GLOBAL SAFETY FIELD INVESTIGATIONS
DCS6545
URGENT - DISTRIBUTE IMMEDIATELY

Subject: REVISION: N222371151-05 - Customer Satisfaction Program
Heated Steering Wheel Retrofit – Steering Wheel Replacement Only
Population Update

N222371151 – Heated Steering Wheel Retrofit – Steering Wheel Replacement Only

Revision: 05

6298325

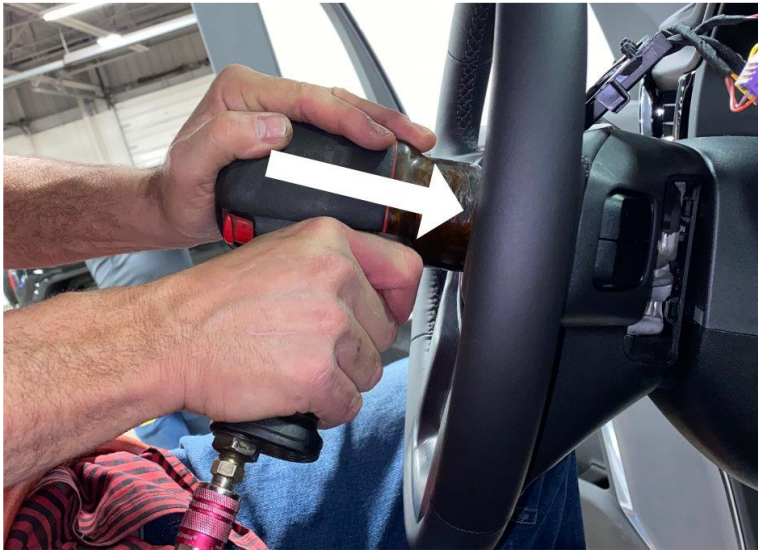
Caution: During steering wheel bolt removal, observe the following precautions:

- Do NOT use heat on the steering wheel bolt, steering wheel, or steering column. Using heat could cause damage to the steering related components.
- Do NOT hammer or apply excessive downward force on the steering wheel bolt, steering wheel, or steering column. Hammering or applying excessive downward force could cause damage to the steering related components.
- Damaged columns due to hammering or excessive downward force can cause a rubbing of the trim pieces potentially leading to a customer comeback.

- Steering wheel bolts installed during manufacturing require high torque efforts to remove.
- The ONLY acceptable bit for removing and installing the steering wheel bolt is a T50 Torx bit. Do NOT use any other size bit or a worn bit.
- If a power tool is used to remove the steering wheel bolt, the tool must have a minimum torque rating greater than **75 NM (55 lb ft)** and both the power tool and the T50 Torx bit MUST be positioned perpendicular to the bolt recess.
- Apply appropriate downward force to maintain engagement of bit to bolt recess during bolt removal.

1. Remove and replace the Steering Wheel. Refer to *Steering Wheel Replacement* in SI.
